Access Compliance Report

Public Rights-of-Way

(Curb Ramps)

Intersection ID: 29156	Main Street: BRANSCOMB_DR	Cross Street: BRIDGEVILLE_LN	Location: SE
ADA ID: E74BFD395C5C	Ramp Type: PerpDiag	Initial Pass/Fail: Pass	Overall Compliance: No
Severity Score: 17.75			
Codes/Mitigation Info/Possible Solution		Field Measurements/Component Compliance

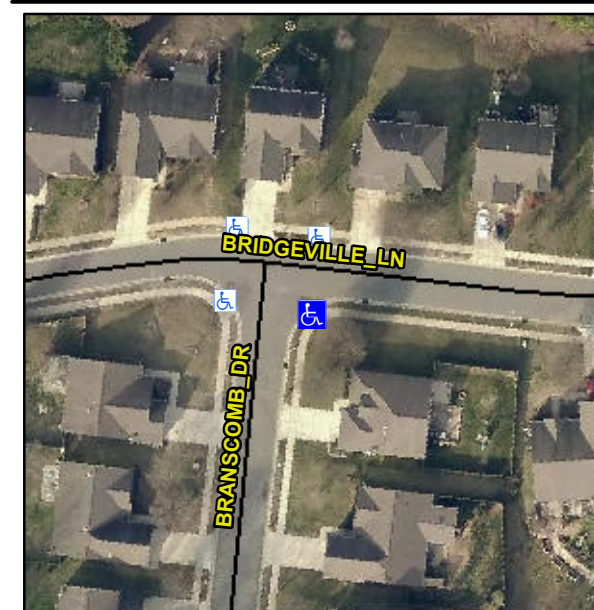
Not Found, R304.5.3, R304.2.1, R305, R302.7.2

Compliance	Description	Data	Compliance	Description	Data
N/A	Ramp Length (in)	48.0	Yes	Ramp Slope (%)	5.1
Yes	Ramp Width (in)	70.0	No	Ramp XSlope (%)	2.4
N/A	Flare Type LT	Sloped	N/A	Flare Type RT	N/A
N/A	Flare Slope LT (%)	1.0	Yes	Flare Slope RT (%)	6.9
N/A	Flare Traversable LT?	Yes	N/A	Flare Traversable RT?	Yes
No	Landing Length (in)	47.0	No	DWS Provided?	No
Yes	Landing Width (in)	70.0	N/A	DWS Contrast?	No
Yes	Landing Slope (%)	0.8	N/A	DWS Length (in)	N/A
No	Landing X Slope (%)	3.4	N/A	DWS Full Width?	No
N/A	Landing Curb? (Y/N)	No	N/A	DWS Offset (in)	N/A
N/A	Shared Landing?	No			
Yes	Gutter Ponding?	No	Yes	Gutter Slope (%)	3.1
No	Gutter Lip Ht (in)	0.5	No	Gutter X Slope (%)	3.1
N/A	Painted X Walk1?	No	N/A	Painted X Walk2?	No
	X Walk 1 Direction	To N		X Walk 2 Direction	To W
N/A	X Walk 1 Width (in)	N/A	N/A	X Walk 2 Width (in)	N/A
	X Walk 1 Slope (%)	2.9		X Walk 2 Slope (%)	3.0
	X Walk 1 X Slope (%)	2.8		X Walk 2 X Slope (%)	2.3

Remove & Replace Curb Ramp With Two New Directional Ramps or Equivalent. Remove & Replace Gutter.
